ARCHITECTURAL REVIEW BOARD MUNICIPAL PLANNING COMMISSION -AGENDA-

Thursday, June 8, 2023 at 7:00 P.M.

MEMORANDUM

SUBJECT: Staff Memo for the Meeting of June 8, 2023

DRAWING NO. ARB 0016-2023

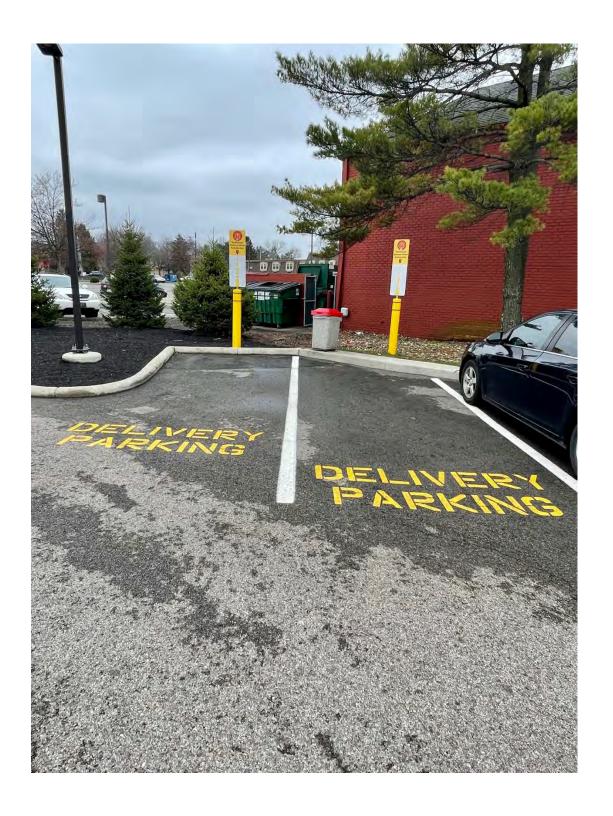
- 1. Staff understands how businesses have needed to change due to the pandemic and the use of technology. Keeping the associated visual clutter to a minimum while providing directional information should be the goal.
- 2. As this restaurant has a third window for drive thru, it is not clear why 2 additional drive thru spaces are needed.
- 3. We are curious to know if 4 curbside pickup spaces are ever used at the same time.
- 4. The drive thru sign and cones should not be necessary.
- 5. If all signs are warranted, the bases and bollards should be changed to a more neutral color rather the main advertising color for the business.

Staff is recommending the applicant re-evaluate the need for the signs, and change the bases and bollards if the signs are necessary.

CITY OF WORTHINGTON
DRAWING NO. ARB 0036-2023

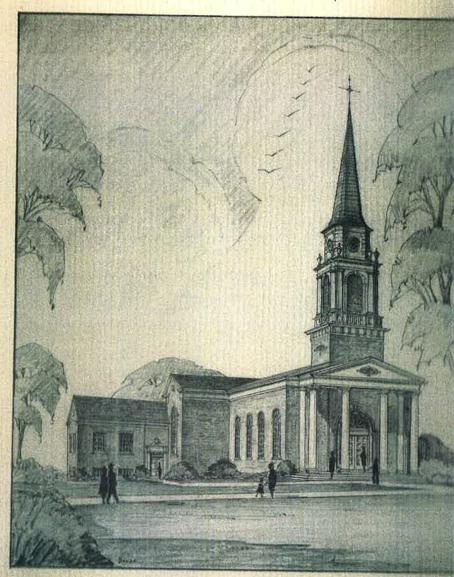
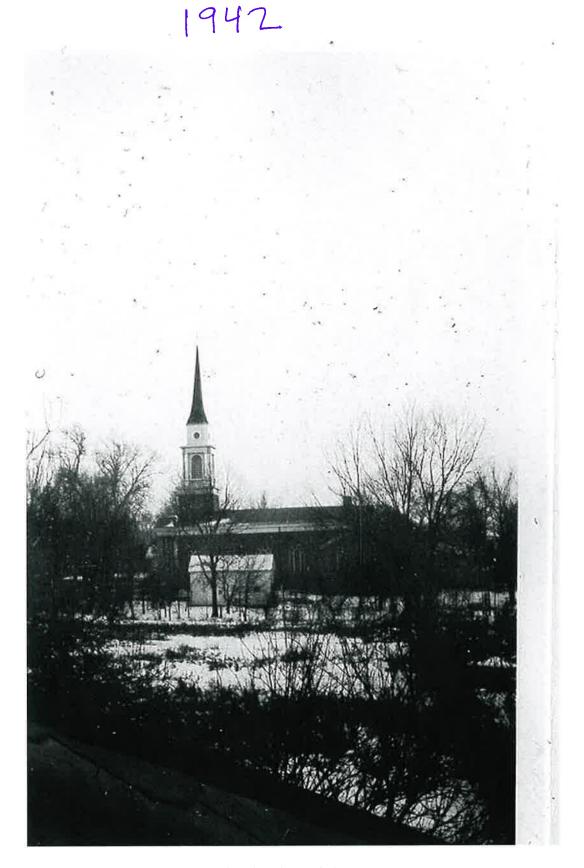
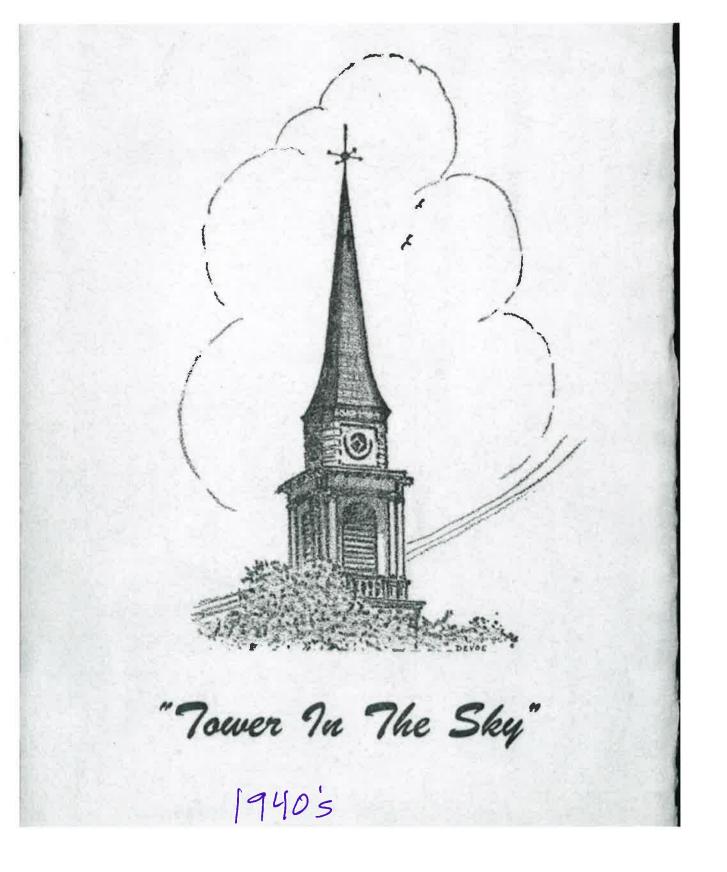
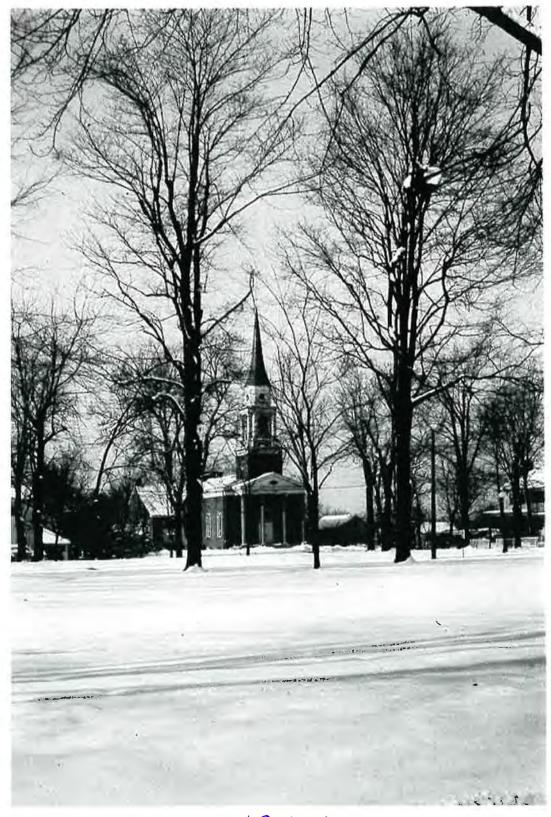
- 1. The applicant has found photos and sketches of the church steeple and narrowed the timeline for arrival of the 8 urns to between 1942 and 1959. There are 2 at each corner of the upper half of the steeple. No documentation was found regarding the project.
- 2. The urns have deteriorated to the point of needing replaced and the church would like to remove them instead due to cost and maintenance. Photos and sketches of the church over the years seem to indicate the urns were not an original part of the steeple

SK Homes proposes to split the Subject Parcel into three parcels, as shown below (a larger Plat is uploaded with the application materials):

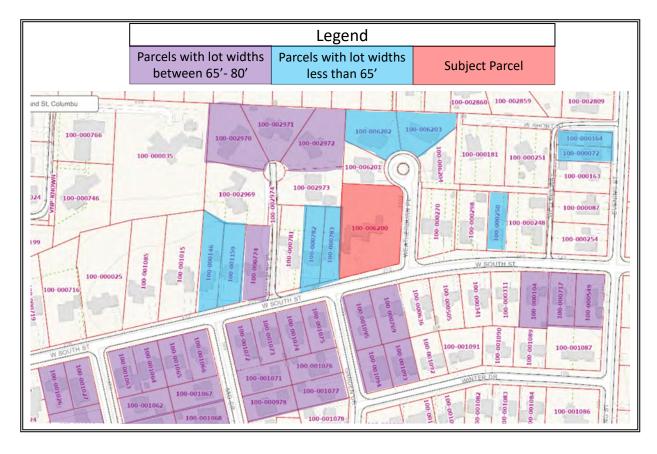
- i. The Service & Engineering Department is asking that the access for Lot #3 (corner lot) be moved north towards the rear property line between Lot #2 and Lot #3 to provide an appropriate distance from the intersection of Weatherburn Pl. and W. South St.

- 1. Preliminary Plat Missing Information:
 - a. Proposed Name of Subdivision
 - b. Location within the City
 - c. Intersecting property lines of adjacent tracts of lands
 - d. Existing zoning classifications and dimensional requirements
 - e. Existing contours with intervals at a minimum of 5-feet
 - f. Any proposed easements
 - g. Preliminary grading plan
 - h. Proposed landscaping and screening plan
 - i. Coordination with an engineer that is familiar with the subdivision requirements.
- 2. Public Area Payment:
 - a. \$250.00/new dwelling unit required at the time of applying for a permit to construct the new dwelling units.
- 3. Special Park Fund:
 - a. \$500.00/newly created lot required at the time of recording the Final Plat.
- 4. Proposed Variances:
 - a. Lot #1
 - i. Rear Yard

Staff is recommending *conditional approval* of the application if the Municipal Planning Commission feels comfortable moving forward with requiring the additional items that are required as part of the Preliminary Plat approval to be submitted with the materials for the Final Plat.

DRAWINGS NO. DEMO 02-2023 SUB 02-2023

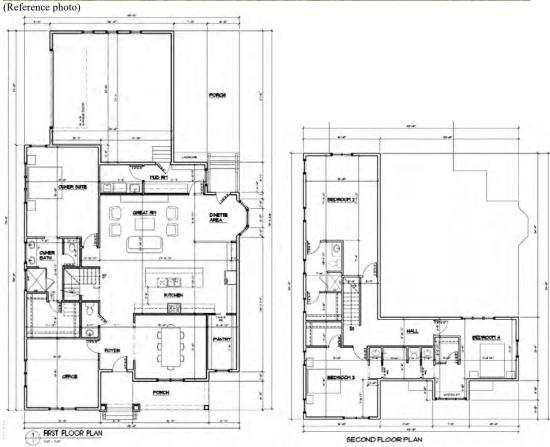
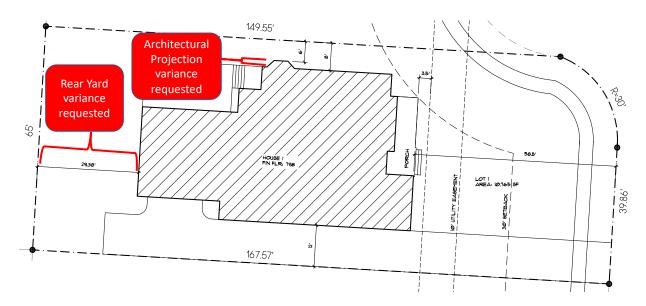
- 1. Required 30-feet
- 2. Proposed 29.4-feet
 - a. Variance of 8-inches
 - i. The variance is not substantial, and the existing sanitary sewer easement pushes the proposed building back further into the lot.
 - ii. A different floor plan might eliminate the need for a variance for the rear setback.

- 1. Required 8-feet, permits architectural projections up to 18-inches
- 2. Proposed 6-feet, this includes the architectural projections to 24-inches.
 - a. Variance of 6-inches
 - i. The variance is not substantial however a different floor plan might eliminate the need for a variance.
- iii. Lot Width
 - 1. Required 80-feet
 - 2. Proposed 67-feet
 - a. Variance of 13-feet
 - i. The lot widths are not out off character for the area. There are a variety of lot sizes and widths found throughout this quadrant of the City.

DRAWINGS NO. DEMO 02-2023 SUB 02-2023

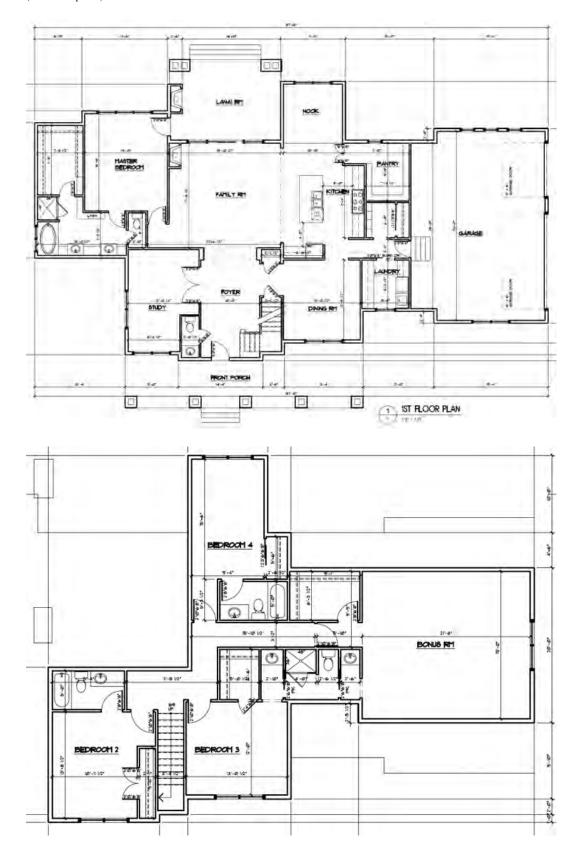
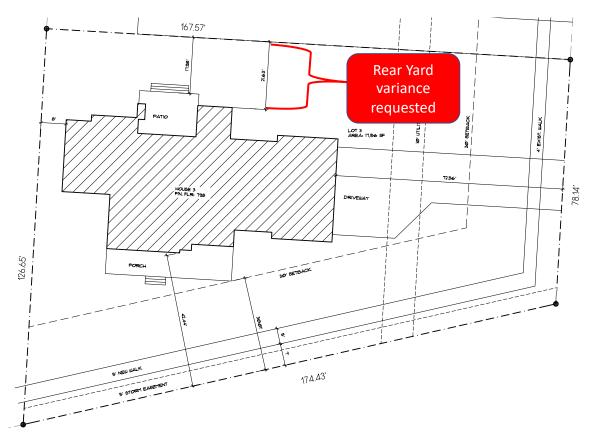
- c. Lot #3
 - i. Rear Yard
 - 1. Required 30-feet
 - 2. Proposed 22-feet
 - a. Variance of 8-feet
 - i. The variance is not substantial; however, a different floor plan might eliminate the need for a variance for the rear setback.
- 5. Tree Projection Plan
 - a. Tree protection fencing needs to be shown on the plans for the trees that are proposed to stay on the site and be protected during demolition and construction of the new single-family homes.
- 6. A Subdivider's Agreement will be required as part of the Subdivision process.
- 7. Since the property is not located in the Architectural Review District, strict adherence to construct the homes as shown in the application materials is not legally possible by the Municipal Planning Commission.
